SEQUOYAH NUCLEAR PLANT (SQN) - REQUEST FOR ADDITIONAL INFORMATION -
RELIEF REQUESTS 1-ISI-22 AND 2-ISI-22

Enclosed is the additional information requested to support NRC review of two TVA relief requests (1-ISI-22 and 2-ISI-22). The additional information was discussed verbally between SQN's inservice inspection staff and NRC technical reviewers during a telephone conference call on November 16, 1995. The enclosed information provides details concerning the ultrasonic examination coverage on SQN's steam generator nozzle-to-safe end welds associated with the subject relief requests.

SKETCH #1

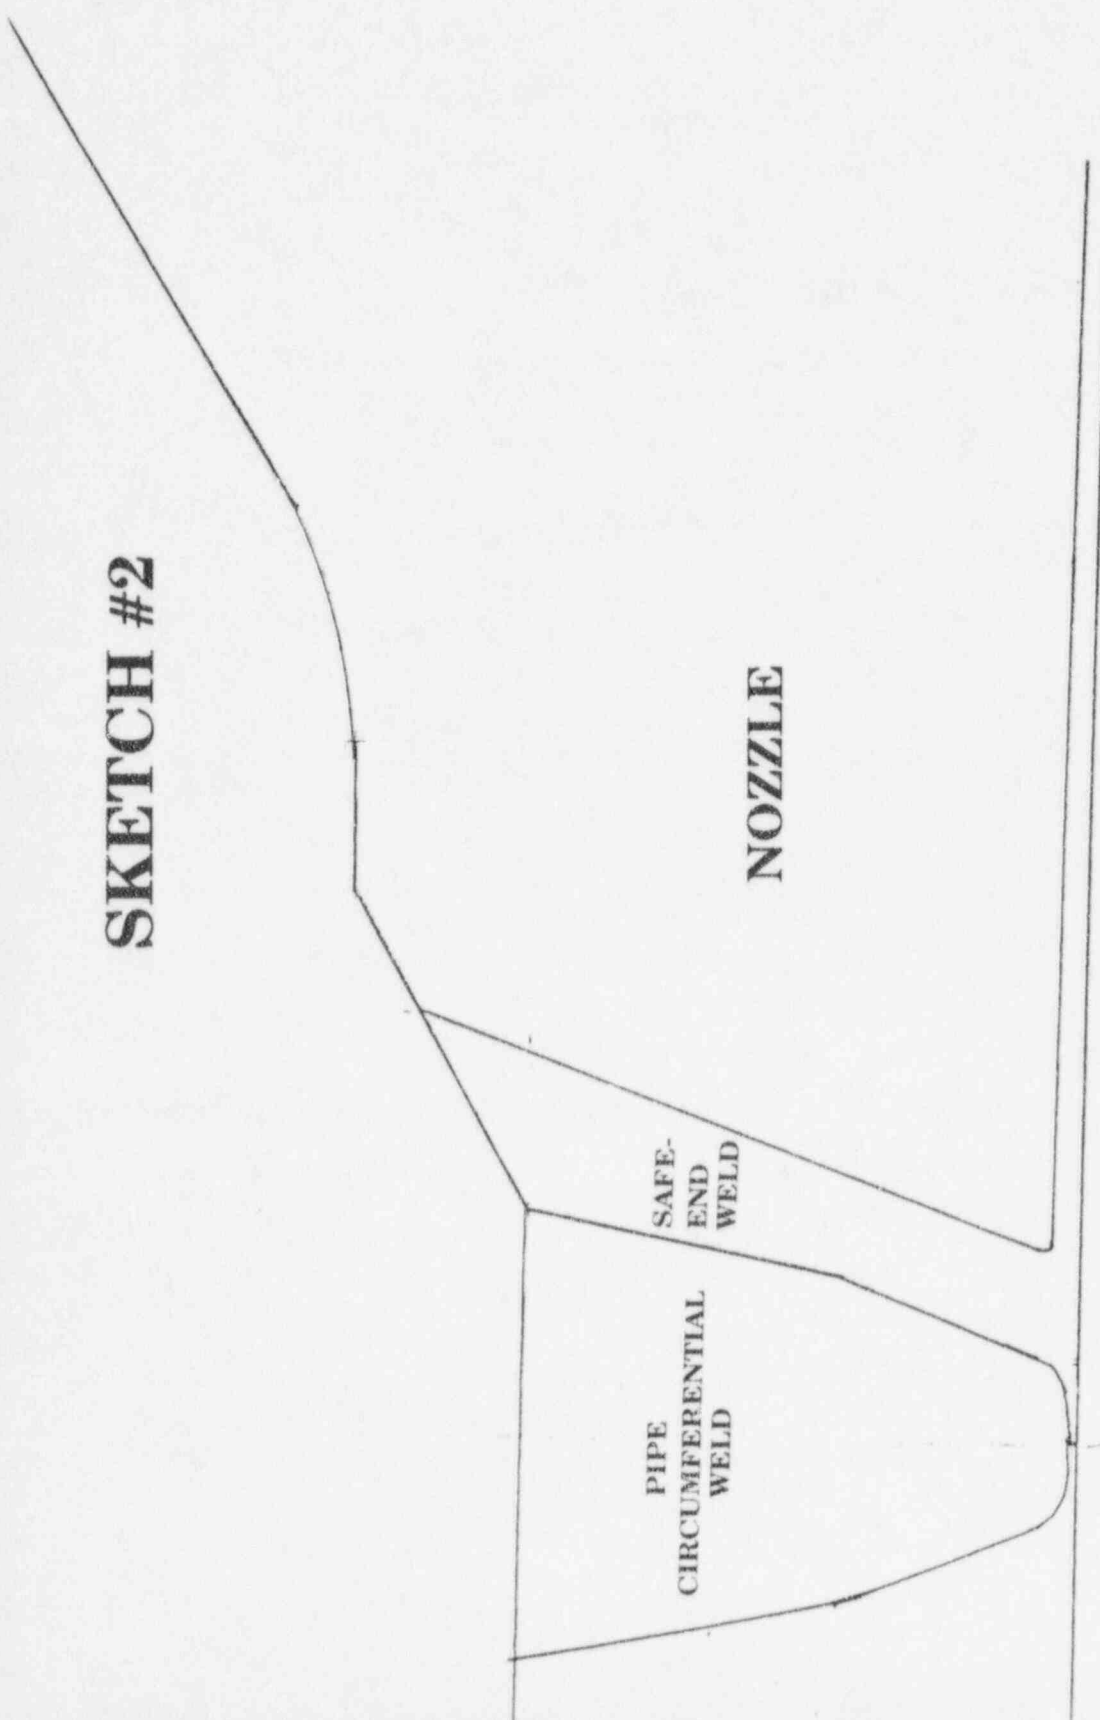
- a. Sequoyah Nuclear Plant (SQN) Units 1 and 2 steam generator (S/G) bottom head is a single piece casting, (SA-216 material) with integral cast nozzles. The Westinghouse Electric Corporation design of the nozzle safe-end welds consist of approximately 0.5-inch layer of TY-308-L weld material (buttering) applied to the nozzle weld edge preparation surface. During the first interval, TVA identified the safe-end as an examination Category B-F weld, separate from the adjacent examination Category B-J circumferential pipe weld. Because of the safe-end-weld configuration, access was extremely limited (see Sketch #1).

SKETCH #2

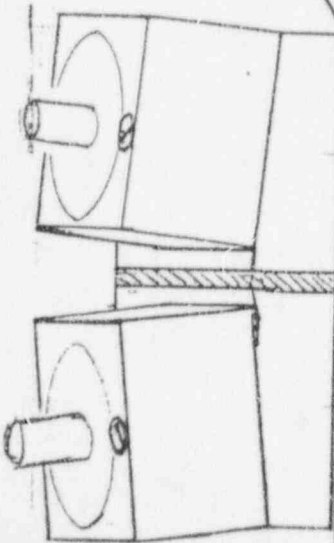
- b. The design configuration of the nozzles does not permit scanning from the nozzle side of the safe-end-weld (see Sketch #2).
- c. The primary loop piping connections at all eight S/G nozzle safe-ends are elbows (i.e., nozzle to static cast stainless fitting) causing an ultrasonic coupling problem when utilizing the large "foot-print" transducers that are required to penetrate the cast stainless material. No examination credit was taken when transducer lift-off was observed due to the rough surface condition of the cast elbow.

SKETCH #3

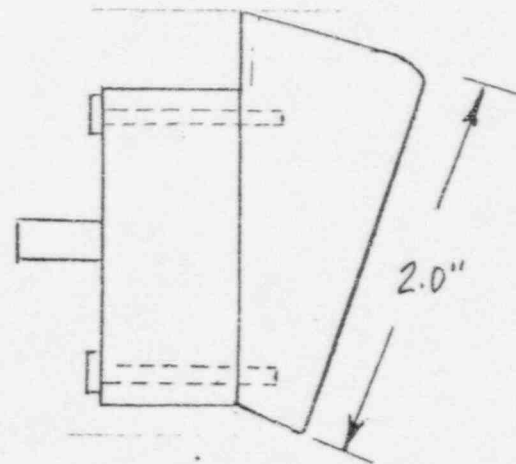
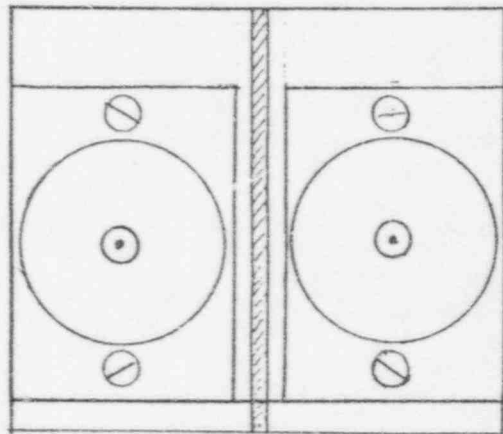
- d. Because of the location of the safe-end weld relative to the transducer location during circumferential scans, no examination credit was taken for the circumferential scans due to the "squint" angle of the transducers not allowing the sound beam to impinge on the area of the safe-end weld (see Sketch #3).

SKETCH #4

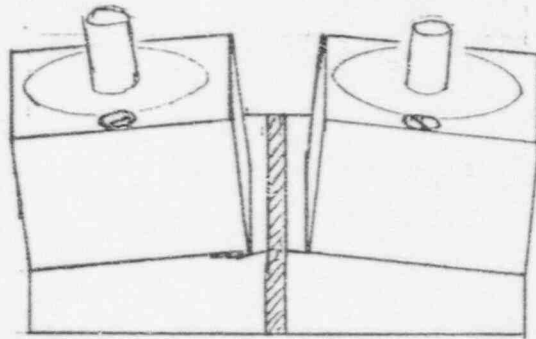
- b. The UT examination was performed utilizing two, one-inch diameter, one megahertz transducers that produced a 45-degree longitudinal wave in the part. The transducers were mounted on a Lucite wedge in a side-by-side, dual, pitch-catch configuration (see Sketch #4).
